## **TAS5504A Errata**

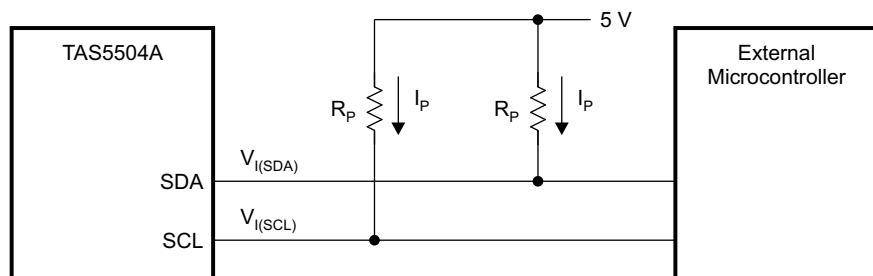
In systems using 5-V CMOS buffers for the I<sup>2</sup>C interface, special pullup resistors are required.

The I<sup>2</sup>C specification requires that  $V_{IH}$  is  $0.7 \times V_{DD} = 3.5$  V when  $V_{DD}$  is 5 V. In some 5-V CMOS systems, the normal value for the I<sup>2</sup>C pullup resistor is 4.7 k $\Omega$ . This could cause the voltage not to rise above 3.47 V, which violates the specification. The root cause has been identified as a TAS5504A 5-V tolerant buffer issue.

It is recommended that the I<sup>2</sup>C pullup resistors,  $R_P$ , be 3.3 k $\Omega$  (see Figure 1). If a series resistor is in the circuit (see Figure 2), then the series resistors,  $R_S$ , should be less than or equal to 300  $\Omega$ .

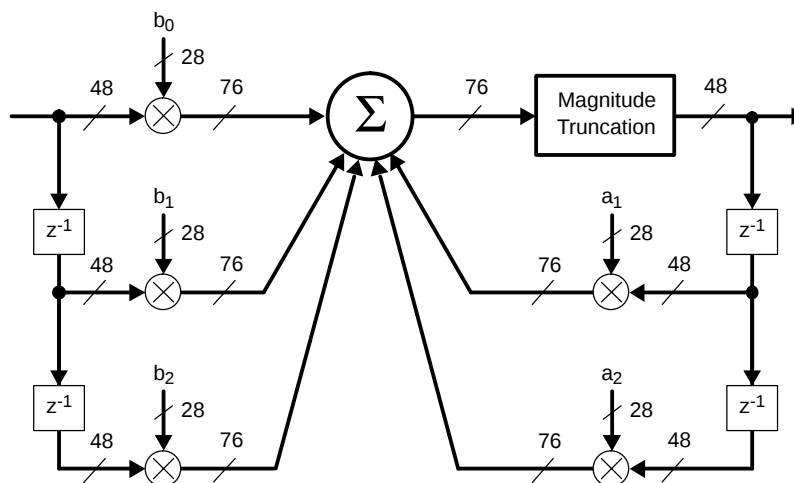
The TAS5504A exhibits a one-sample delay on channels 3 and 4 for sample rates of 32, 44.1, and 48 kHz. The delay occurs in the PWM section.

This time misalignment can impact applications where the TAS5504A is used to provide crossover filtering and bi-amplification, as in powered loudspeakers. The problem that occurs in these cases is that a one-sample time delay in either the high-pass or low-pass path causes an error in the overall crossover frequency response.

The time misalignment can be corrected by using a biquad to provide a one-sample delay for each of the nondelayed PWM channels for the 48-, 44.1-, and 32-kHz sample rates.

1. Set the b1 biquad coefficients to a gain of 1.
2. Set all of the other biquad coefficients (b0, b2, a1, and a2) to a gain of 0, as shown in the following diagram and table.
